ACCESSION NBR: 7908200365 DOC. DATE: 79/08/14 NOTARIZED: NO DOCKET #  
 FACIL: 50-387 Susquehanna Steam Electric Station, Unit 1, Pennsylv 05000387  
 .50-388 Susquehanna Steam Electric Station, Unit 2, Pennsylv 05000388  
 AUTH. NAME AUTHOR AFFILIATION  
 MOSES, L. Affiliation Unknown  
 RECIPIENT NAME RECIPIENT AFFILIATION  
 Division of Site Safety & Environmental Analysis

SUBJECT: Opposes nuclear reactors & waste of electrical power.

Attached are PP&L's comments on the Draft Supplement to the Draft Environmental Statement related to operation of the Susquehanna Steam Electric Station (NUREG-0564). If you have any questions on these comments, please contact W. E. Barberich (Phone 215-821-5833).

Fig. 2.3. Water Use Diagram for Susquehanna Units 1 and 2. From ER-OL, Fig. 3.3-1.

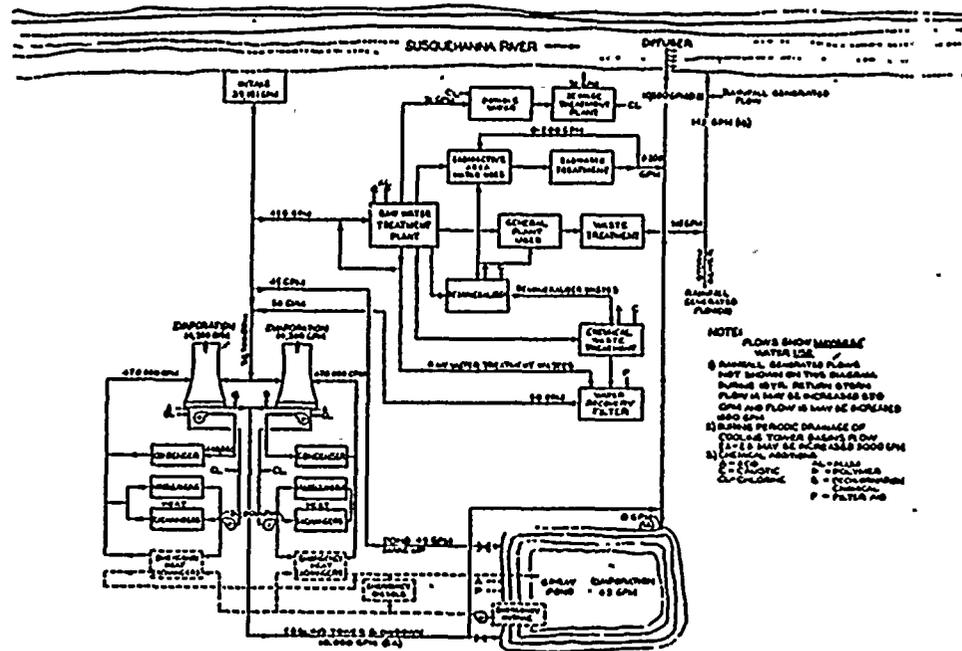
1. Section 2.3.3, pg. 2-11 - Figure 2.3, Water Use Diagram has been revised per the NPDES permit. The parking area hold-up pond has been deleted (see revised Figure 2.3, attached)
2. Section 2.3.4.1, pg. 2-11 - On "line 1" - The monitoring schedule ranged from twice weekly to quarterly. On "line 2" - The monitoring by Ichthyological Associates since 1971 has been weekly instead of daily. Line 8 should read total iron "and fecal coliforms". Figures 2.5 and 2.6 are reversed.
3. Section 2.5.1.3, pg. 2-22 - Add to line 12; "An American peregrine falcon was observed in 1973.:"
4. Section 2.4.2, pg. 2-11 - Local Meteorology

1. Section 3.2.4.1, pg. 3-8 - The parking area hold up pond has been deleted. See revised Figure 2.3 which is attached.
